**TOWN OF LOS GATOS
PLANNING COMMISSION
REPORT**

SUBJECT: ARCHITECTURE AND SITE APPLICATION S-15-056, CONDITIONAL USE PERMIT APPLICATION U-15-009, AND ENVIRONMENTAL IMPACT REPORT EIR-16-001. PROJECT LOCATION: 401-409 ALBERTO WAY. PROPERTY OWNER: CWA REALTY. CONTACT PERSON: SHANE ARTERS, LP ACQUISITIONS, LLC.
REQUESTING APPROVAL TO DEMOLISH THREE EXISTING OFFICE BUILDINGS AND CONSTRUCT A NEW, TWO-STORY OFFICE BUILDING WITH UNDERGROUND PARKING ON PROPERTY ZONED CH. APN 529-23-018.

RE: Planning Commission Public Hearing of May 10, 2017 – Supplemental Responses
401-409 Alberto Way
Architecture and Site Application S-15-056
Conditional Use Permit Application U-15-009
APN 529-23-018

405 Alberto Way (Formerly 401-409) Alberto Way Project Comment and Response Matrix

Figure 1: Plate 1 of the Inundation Map of Lexington Dam prepared by Santa Clara Valley Water District

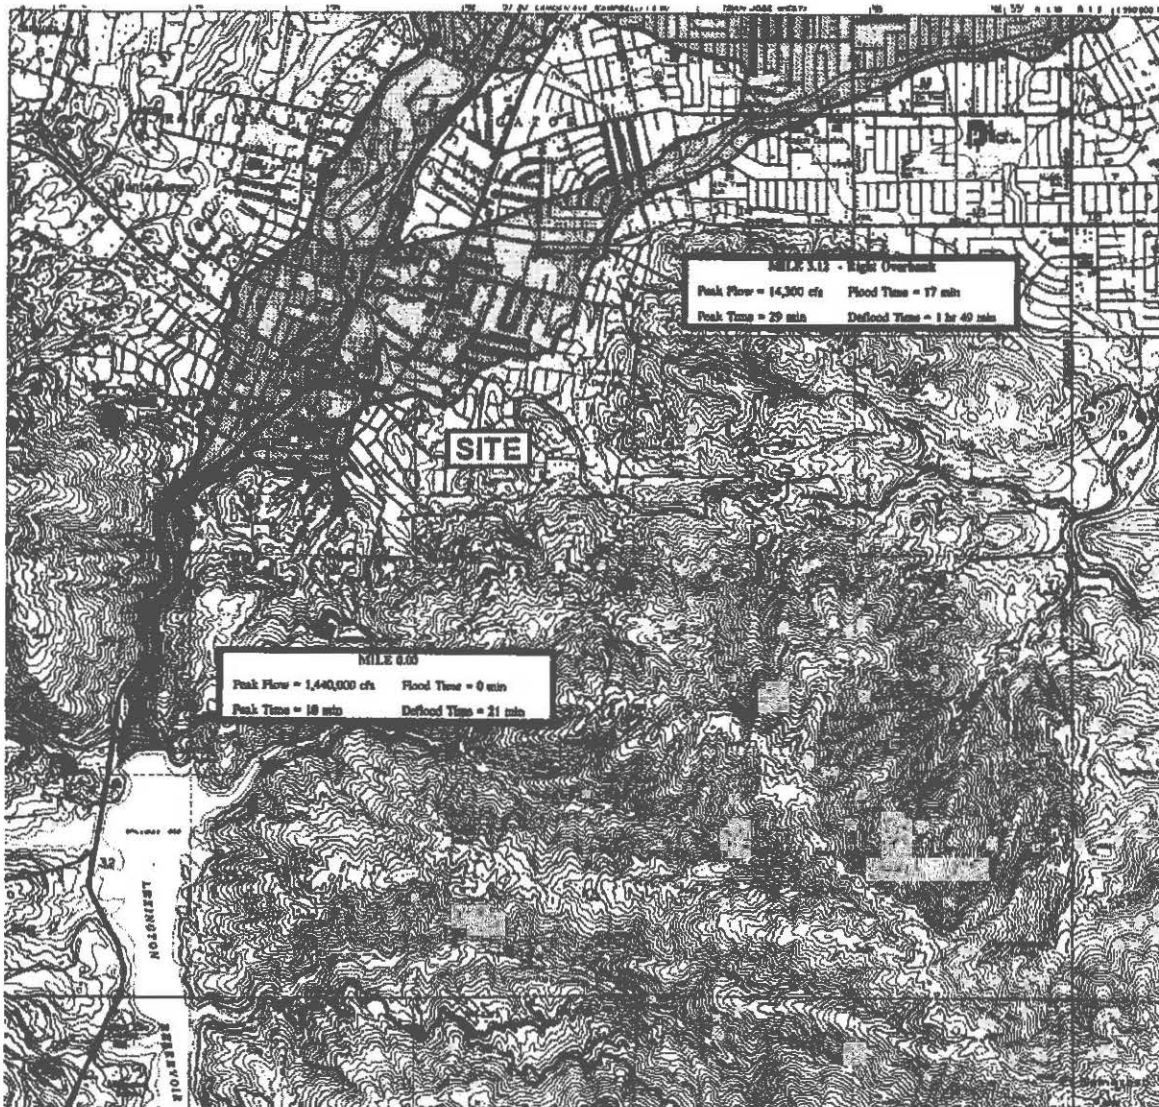
Likelihood of flooding due to upstream dam failures.	Geissler, pp. 2-3, 8-9	New comment included in April 6, 2017 Staff Report	N/A	See Response to Comment 1 in the ENGEO April 19 th Supplemental Responses. The project site, the neighboring properties, and the majority of the Town of Los Gatos are all located in an inundation zone in the event of dam overflow or failure.	Section 3.8, Hydrology and Water Quality in Draft EIR and ENGEO, Inc., 401 Alberto Way, Los Gatos, California, Geotechnical Exploration Report dated July 17, 2015, Rev. August 13, 2015; ENGEO April 19 th Supplemental Responses

As shown on Plate 1 of the Inundation Map of Lexington Dam prepared by Santa Clara Valley Water District (Figure 1), the project site, the neighboring properties, as well as the majority of the Town of Los Gatos, are located within the inundation zone in the event of dam overflow or failure.

It is the responsibility of the Santa Clara Water District (SCVWD) to perform surveillance, inspections and maintenance to reduce the risk of dam failure and overtopping. Moreover, SCVWD collaborates with local public agencies such as the Town of Los Gatos to provide warnings and emergency response.

Figure 2: State of California Special Studies Zone Map, Los Gatos Quadrangle, 1991

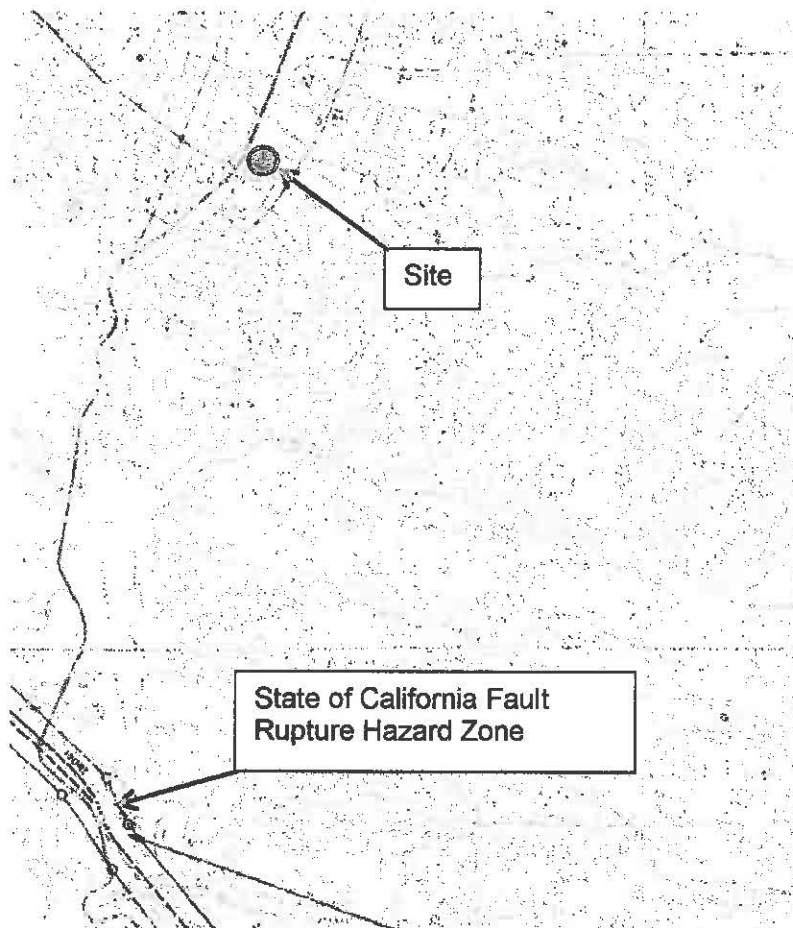
Page 5, Earthquake Risk Section: The project is located within an Earthquake Induced Liquefaction Hazard Zone. The risk of earthquake induced liquefaction hazard has been determined to be high by the Santa Clara Planning Department. [Ref: Santa Clara County Hazard Mitigation Plan dated February 21, 2012]. Plate 1.2 of the Seismic Hazard Zone Report for the Los Gatos Quadrangle (2002) indicated a likelihood of liquefaction that requires mitigation measures are required as per Public Resources Code Section 2693 (c). The ENGEO Report admits that the strata of clayey gravels soils at the subject property... 26th Annual ASCE Los Angeles Geotechnical Spring Seminar]

We disagree with Geissler Engineering on the statement quoted under Comment 8. The project site is not located within State of California Fault Rupture Hazard Zone (Los Gatos Quadrangle, 1991) as shown on Figure 2.

A further description of local faults in the project vicinity and the associated ground rupture hazards can be found in our project geotechnical report. We conclude the potential for surface fault rupture at the site is unlikely.

SURFACE FLOW EXHIBIT
401 ALBERTO WAY

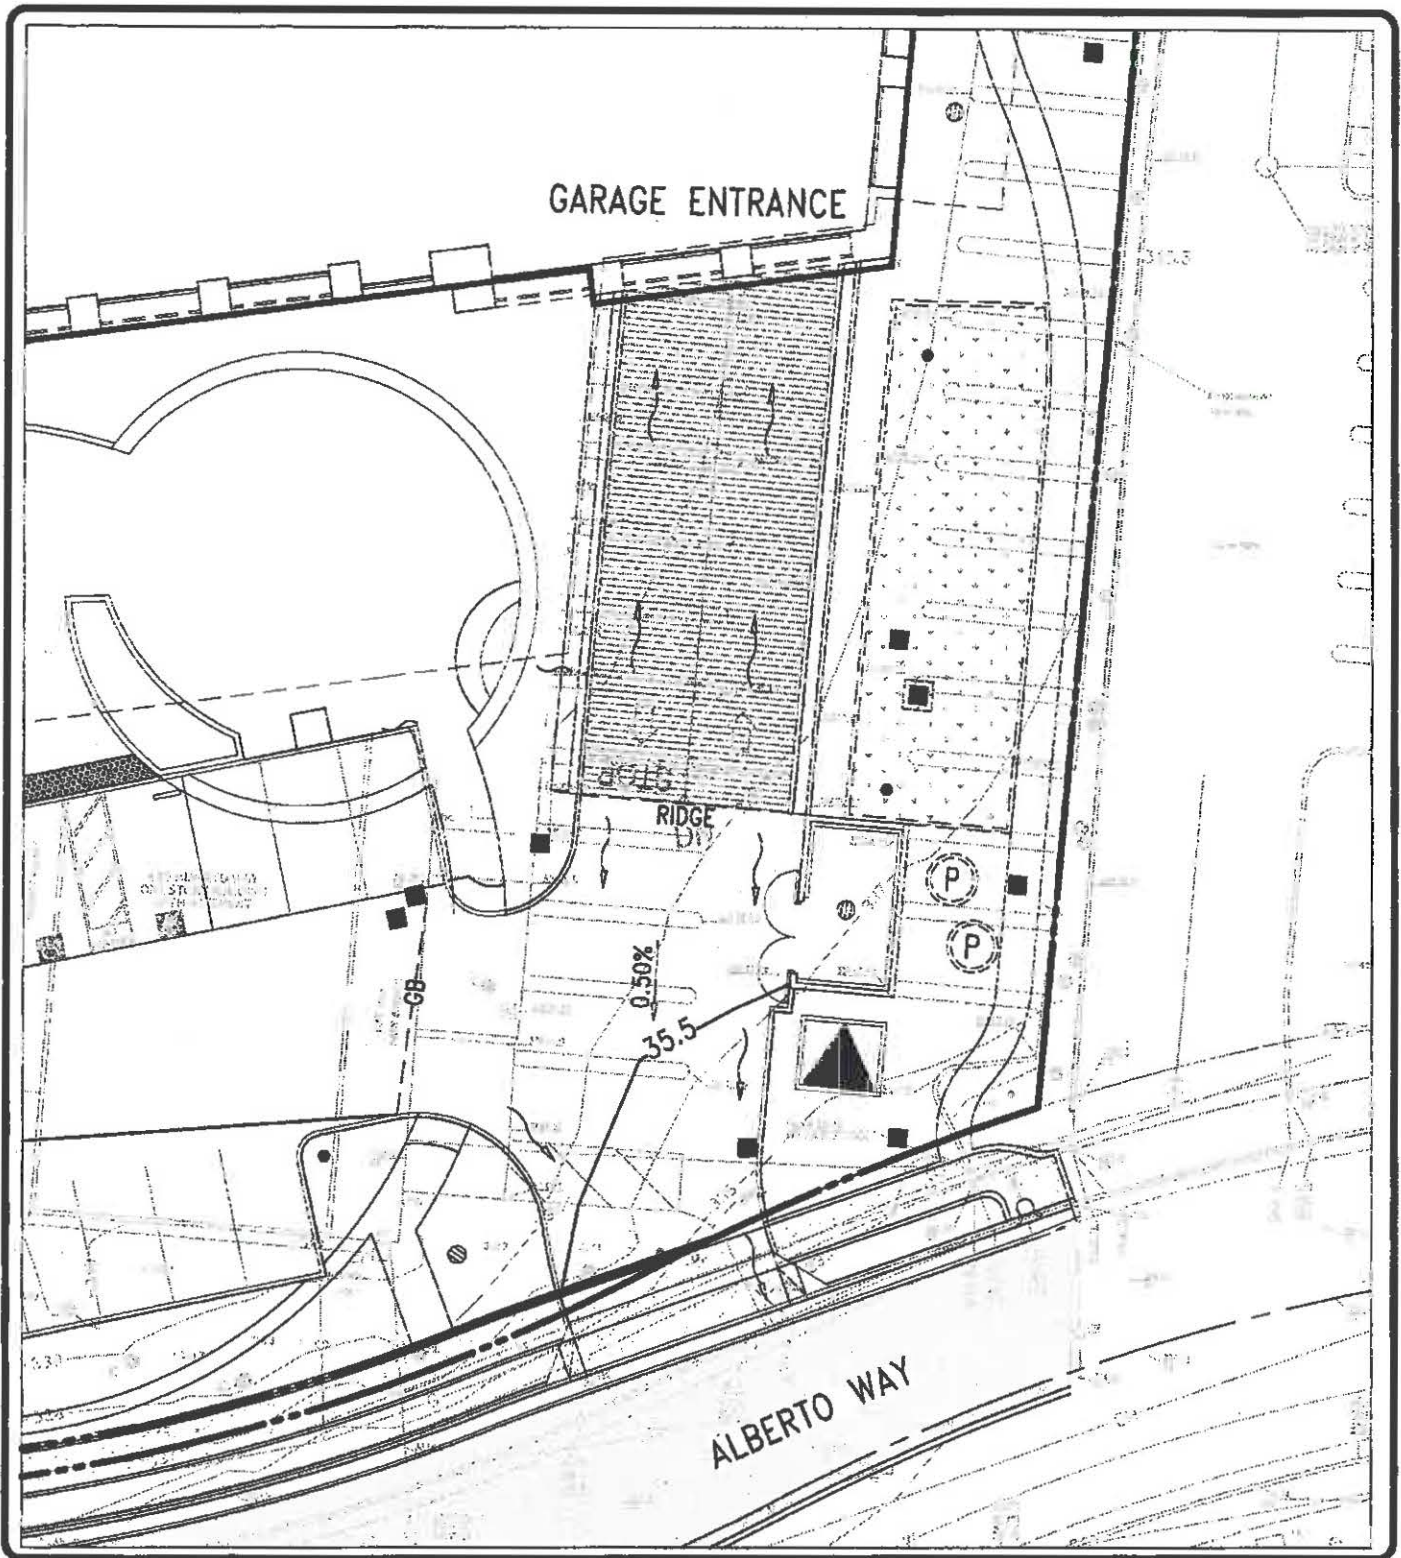
Utilities and Service Systems					
Project sewer crosses neighboring properties.		New comment included in April 6, 2017 Staff Report	N/A	The existing buildings drain the site sewage to a 6' VCP which traverses through the neighboring property. The proposed building for the Project has capped the traversing 6' VCP onsite, and instead is draining the sewage of the proposed building directly into Alberto Way's 6' VCP sewer main, without traversing through a neighboring property. Please see Exhibit 2.	Exhibit 2 to this matrix.

Figure 2: State of California Special Studies Zone Map, Los Gatos Quadrangle, 1991

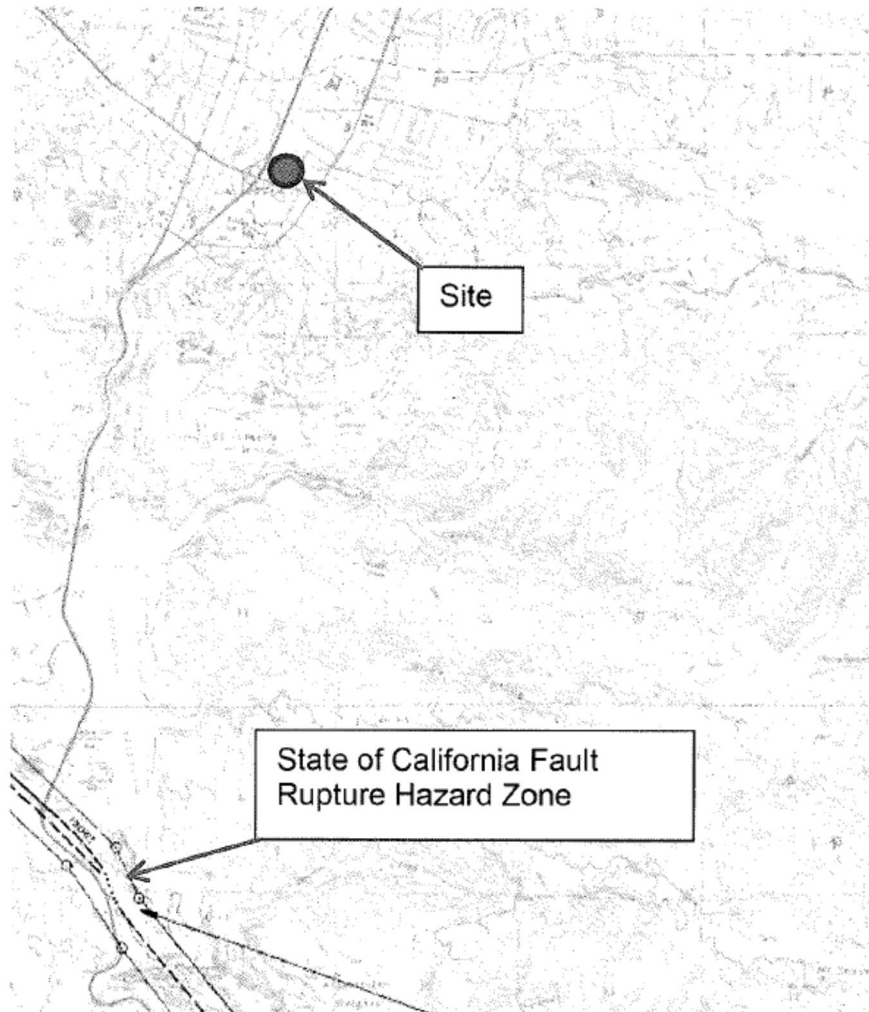
Citizen's Rebuttal to ENGEO on Geissler 4 & 8:

We disagree with Geissler Engineering on the statement quoted under Comment 8. The site is not located within State of California Fault Rupture Hazard Zone (Los Gatos Quad 1991) as shown on Figure 2.
